Working Party on the Construction of Vehicles

REVISED PROPOSAL FOR DRAFT 06 SERIES OF AMENDMENTS TO
REGULATION No.16
(UNIFORM PROVISIONS CONCERNING THE APPROVAL
-1) OF SAFETY-BELTS AND RESTRAINT SYSTEMS FOR OCCUPANTS OF POWER
DRIVEN VEHICLE
-2) OF VEHICLES EQUIPPED WITH SAFETY-BELT)

Transmitted by the French Delegation

- In annexe 17 Appendix 2, modify the table and add the following caption to read :

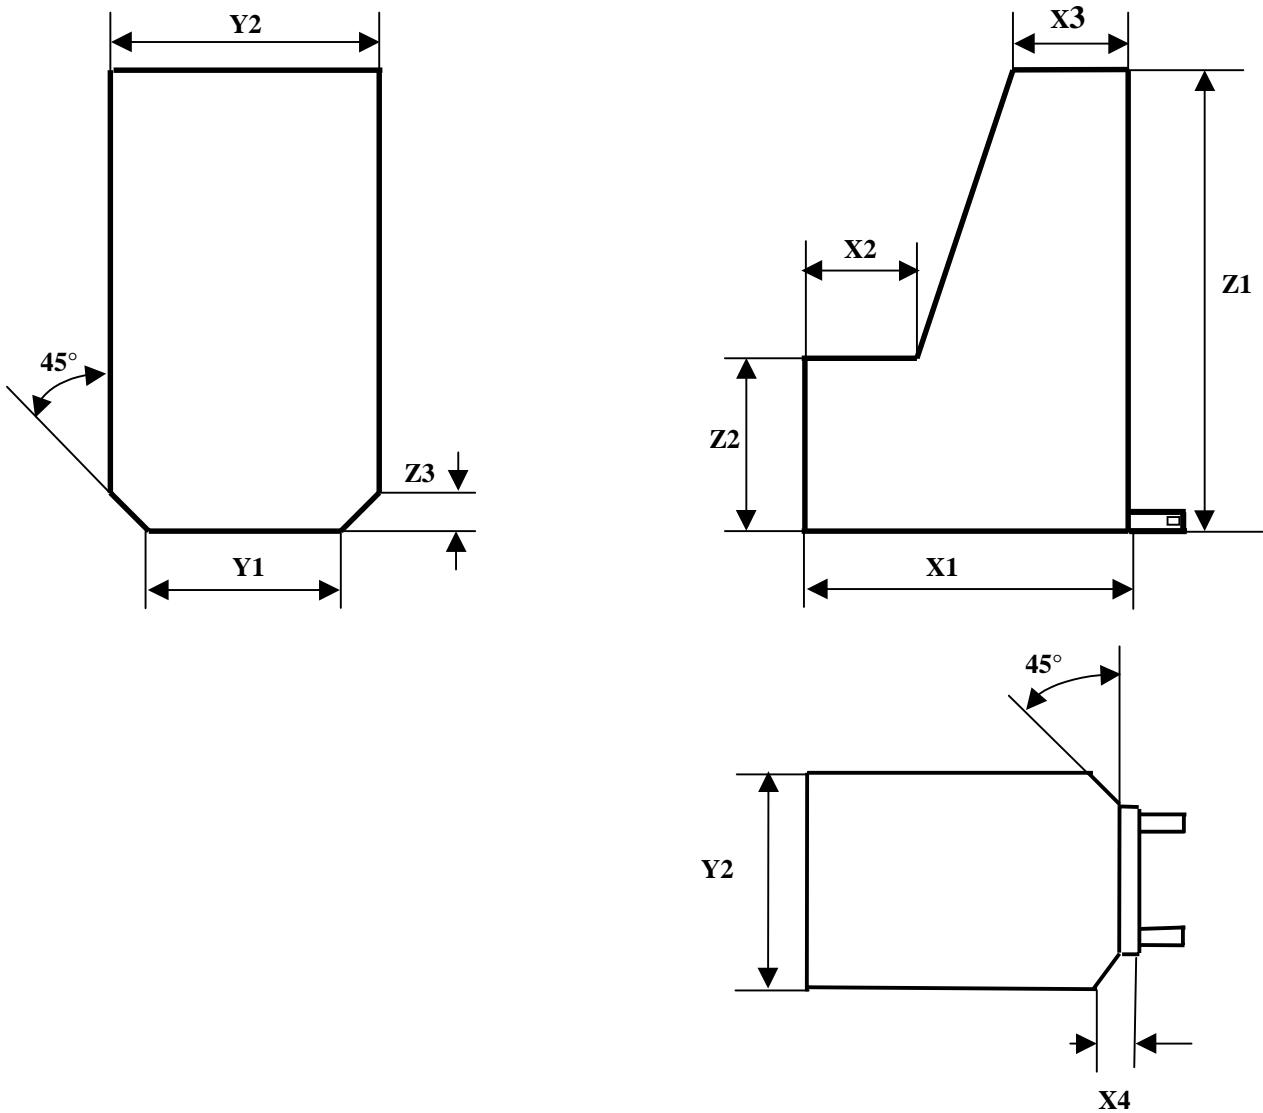
B = Built-in restraint approved for this mass group.

IFF = Suitable for ISOFIX forward facing child restraint systems (see figure 1) for use in this mass group.

IRF = Suitable for ISOFIX rearward facing restraint systems (see figure 2) for use in this mass group.

Figure 1 :Space required for ISOFIX forward facing child restraint systems (IFF)

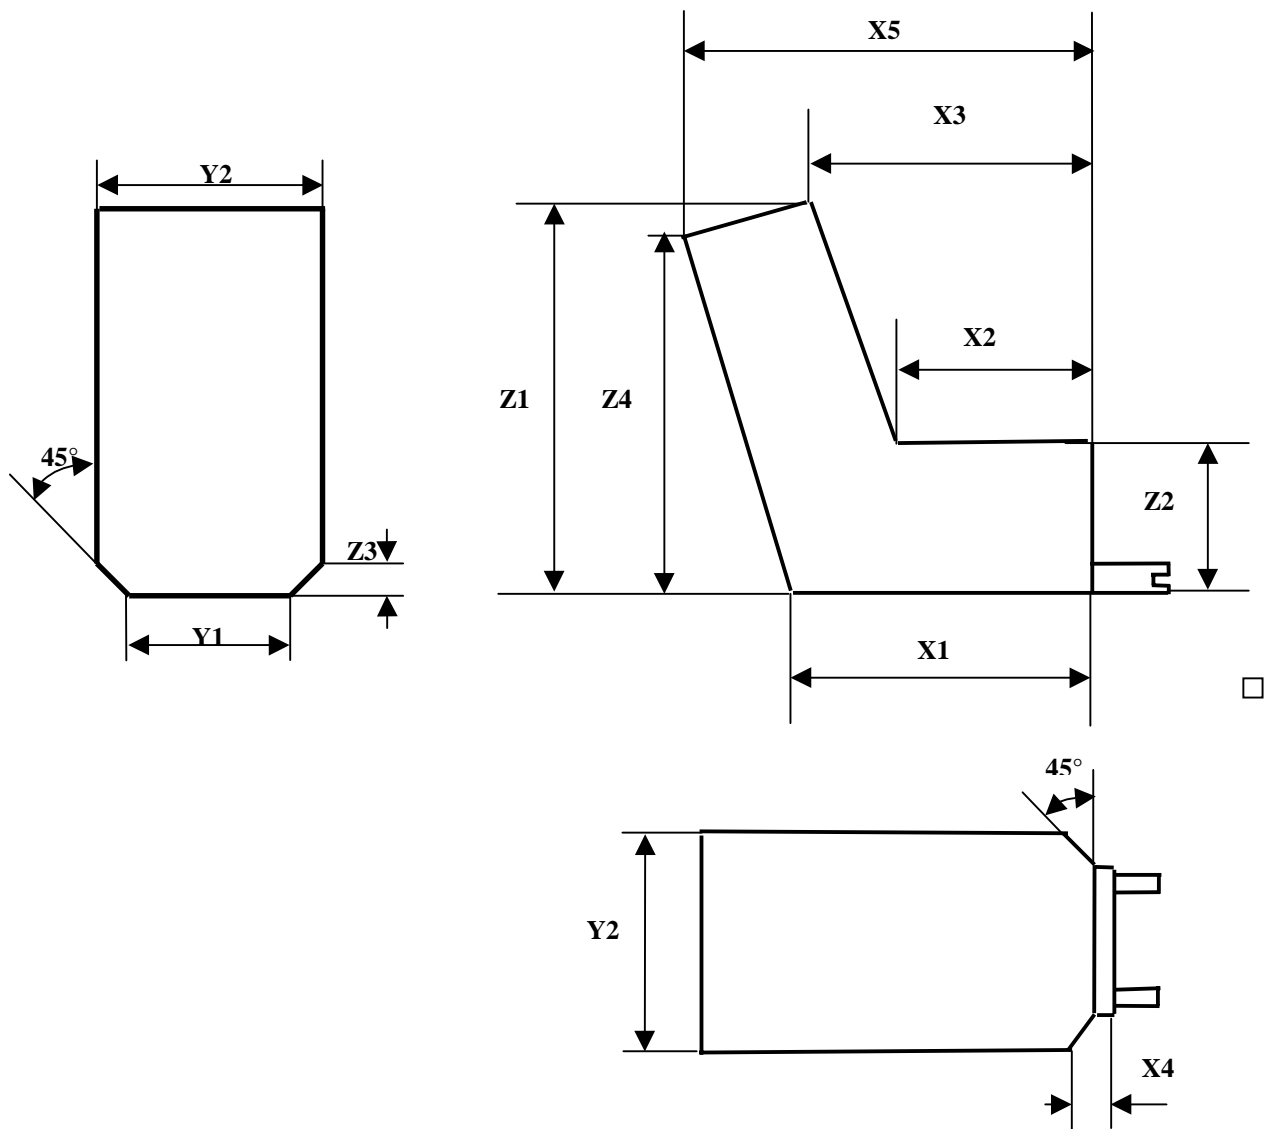
➤ In annexe 17 Appendix 2, add the 2 following figures :
